WSL3 – Replacing the Electric Passenger Compartment Heater (Workshop Campaign)

Model Line: **Taycan (Y1A/Y1B/Y1C)**

Concerns: **Electric passenger compartment heater**

WSL3

Installation Position

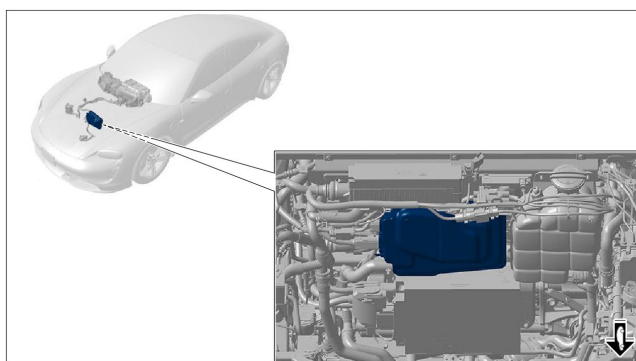
Cause: **The available vehicle data shows that there may be short-term functional restrictions in the electric passenger compartment heater.**

To ensure the heating and dehumidification function, it is necessary to replace the electric passenger compartment heater.

- **(Replacing)** Electric passenger compartment heater

Action: Replace the electric passenger compartment heater.

82566811

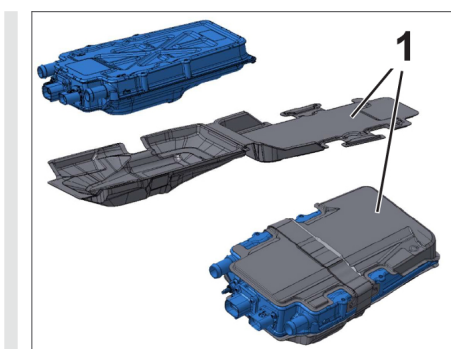
Please note that only vehicles with equipment add-on **auxiliary heater (M No. 9M3)** have an **additional** thermal insulation (case) -1- fitted on the electric passenger compartment heater. This must be transferred from the old to the new electric passenger compartment heater.
